**RESPONSES TO COMMENTS RECEIVED**

**OPEN HOUSE PUBLIC INVOLVEMENT MEETING**

**Cleveland Massillon Road  
Improvement Project**

**SUM-Cleveland Massillon Rd PID 103293**

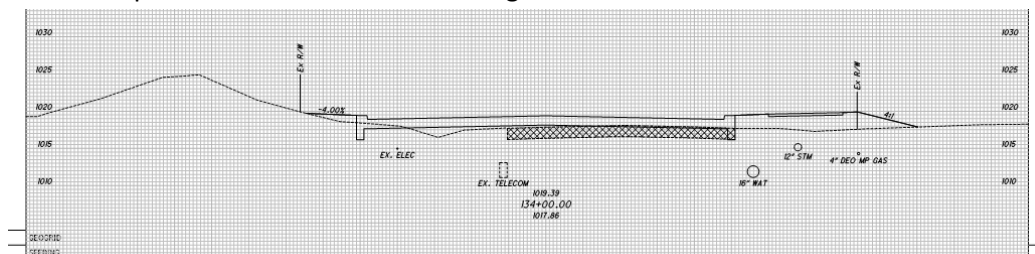
4. We are assuming that the widening of C/M Road to the north of the roundabout will result in the taking of the trees and mounding along our eastern border. We understand that replacing this would be at the expense of the project. We would like to be involved in the design and layout of any improvements.

**Response:** The widening of Cleveland Massillon Road along the eastern border with CrossPoint will not impact the mound and the existing trees will remain. See cross section below.
